Access Compliance Report

Public Rights-of-Way

(Curb Ramps)

Intersection ID: 13593	Main Street: MERRIMAN_AV	Cross Street: SPRUCE_ST	Location:	N
ADA ID: 6BD816B7104A	Ramp Type: BlendTrans1	Initial Pass/Fail: Fail	Overall Compliance: No	Severity Score: 1.25

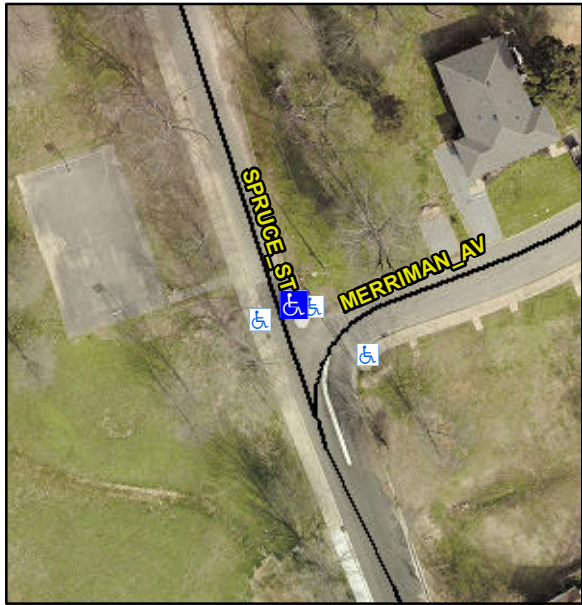
Codes/Mitigation Info/Possible Solution			Field Measurements/Component Compliance					
	Possible Solutions:		Compliance	Description	Data	Compliance	Description	Data
	Remove & Replace Curb Ramp With Two New Directional Ramps or Equivalent.		N/A	Ramp Length (in)	23.0	Yes	BlendTrans Slope (%)	1.7
			Yes	Ramp Width (in)	48.0	No	BlendTrans XSlope (%)	2.5
			N/A	Flare Type LT	N/A	N/A	Flare Type RT	N/A
			N/A	Flare Slope LT (%)	N/A	N/A	Flare Slope RT (%)	N/A
			N/A	Flare Traversable LT?	N/A	N/A	Flare Traversable RT?	N/A
			N/A	Landing Length (in)	N/A	N/A	DWS Provided?	N/A
			N/A	Landing Width (in)	N/A	N/A	DWS Contrast?	N/A
			N/A	Landing Slope (%)	N/A	N/A	DWS Length (in)	N/A
			N/A	Landing X Slope (%)	N/A	N/A	DWS Full Width?	N/A
Surveyor Notes:		N/A	N/A	Landing Curb? (Y/N)	N/A	N/A	DWS Offset (in)	N/A
PROW/ADA:		Not Found, R304.5.3	N/A	Shared Landing?	N/A			
			N/A	Gutter Ponding?	N/A	N/A	Gutter Slope (%)	N/A

N/A	Gutter Lip Ht (in)	N/A	N/A	Gutter X Slope (%)	N/A
			N/A	Painted X Walk1?	No	N/A	Painted X Walk2?	N/A
				X Walk 1 Direction	To SW		X Walk 2 Direction	N/A
				X Walk 1 Width (in)	N/A		X Walk 2 Width (in)	N/A
				X Walk 1 Slope (%)	1.5		X Walk 2 Slope (%)	N/A
				X Walk 1 X Slope (%)	1.7		X Walk 2 X Slope (%)	N/A
			N/A	Ramp inside XWalk1?	N/A	N/A	Ramp inside XWalk2?	N/A
				Road Slope (%)	1.7		Clear Space?	N/A
				Road X Slope (%)	1.5	N/A	Clear Space to XWalk (in)	N/A
			N/A	Any Obstructions?	N/A	N/A	Storm Grate/Utility Hazard?	N/A
				Obstruction Type			Storm Grate/Utility Type	
					N/A			N/A
						Yes	Surface Condition? (G/P)	Good
						No	Curb Slope (%)	19.4
